ITEM FOR ENVIRONMENTAL BOARD AGENDA

**NAME & NUMBER
OF PROJECT:** Wildflower Commons/PUD
C814-06-0233

SUBJECT: Wildflower Commons PUD - C814-06-0233
4700 – 5200 Blocks of State Highway 45

SUBJECT: Corrections to ERM's August 22, 2007 memo regarding Critical Environmental Feature setbacks of Wildflower Commons.

Map 1: Location Map for Critical Environmental Feature Setbacks
(Revised - 07-07-2008)

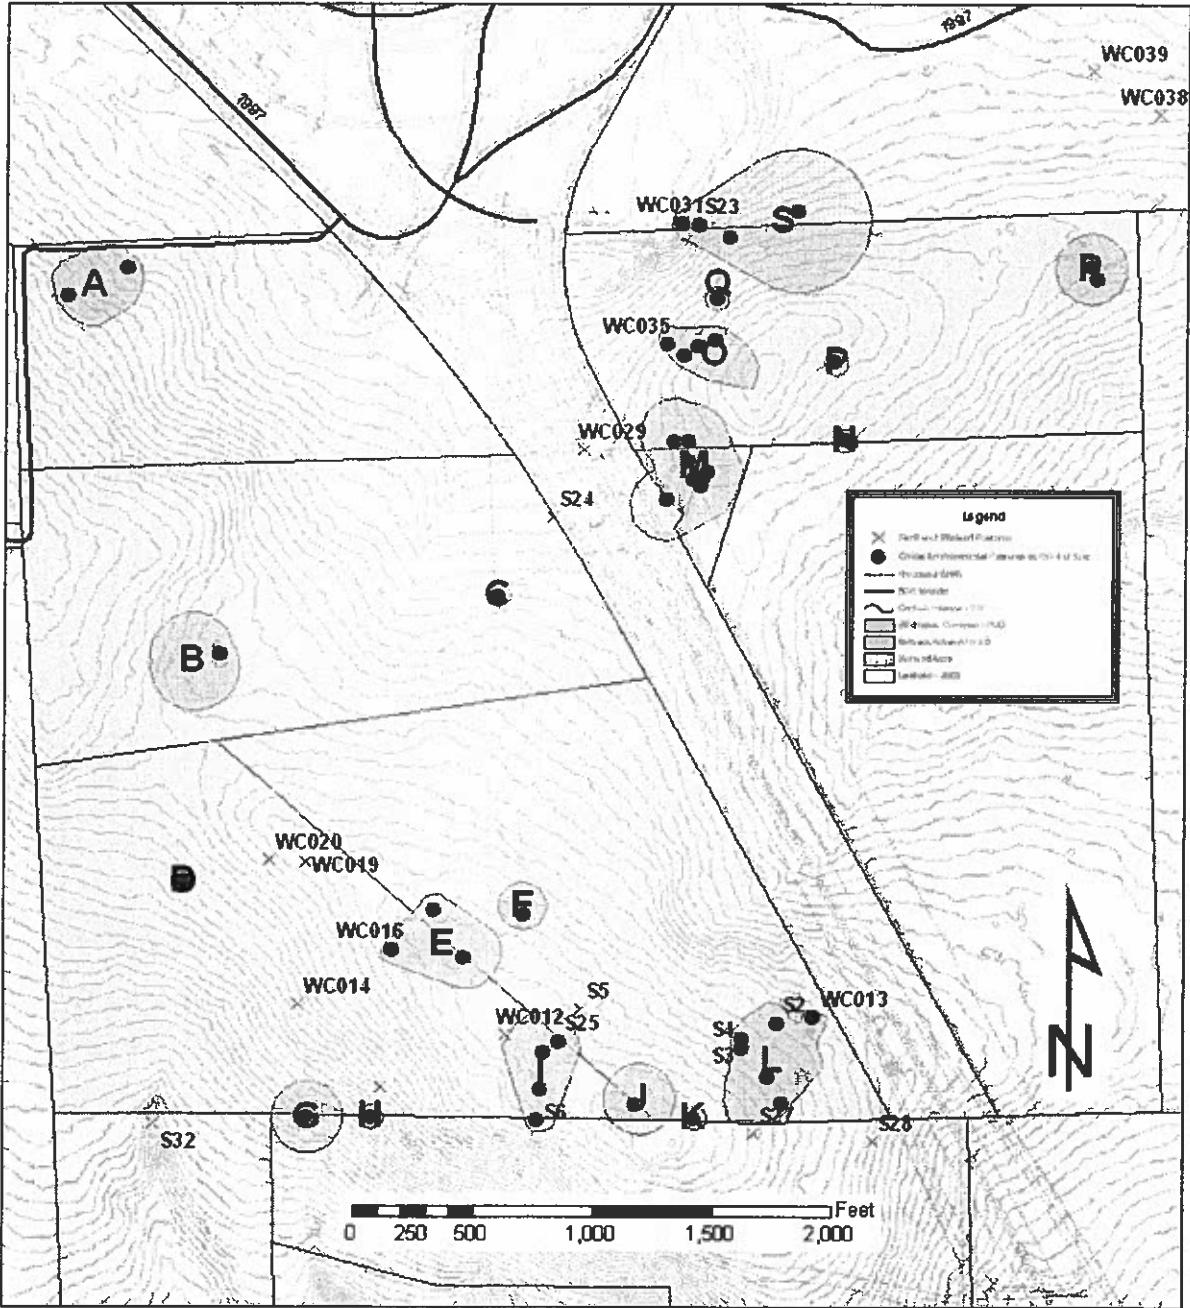
Based the surface drainage patterns, 2-ft topography, the type of feature, the feature's size and the density (or clustering) of features, ERM staff is recommending protecting the critical environmental features with 19 critical environmental feature setback areas (Labeled A thru S). The attached map shows the location of the setback areas. ERM staff is recommending that the CEFs and their associated setback area (or buffers) are documented within the PUD ordinance along with the following Land Development Code (LDC) requirements from Section 25-8-281.

1. No residential lots may include a CEF or be located within 50 feet of a CEF.
2. Setback areas must be established to protect all CEFs. Although the LDC allows a portion of the CEF buffer to be included in a residential lot, I do not recommend that this be allowed. Residential lots should not include any portion of a CEF buffer. Setbacks must comply with the setback area has stated in Table 1 and shown Map 1. ERM is willing to revise setback areas listed in Table 1 and shown on Map 1 during PUD process, if the applicant provides more detail

information to ERM staff such as 1-ft topographic survey that better delineates the catchment areas and a hydrogeologic assessment of the features that better evaluates its recharge potential.
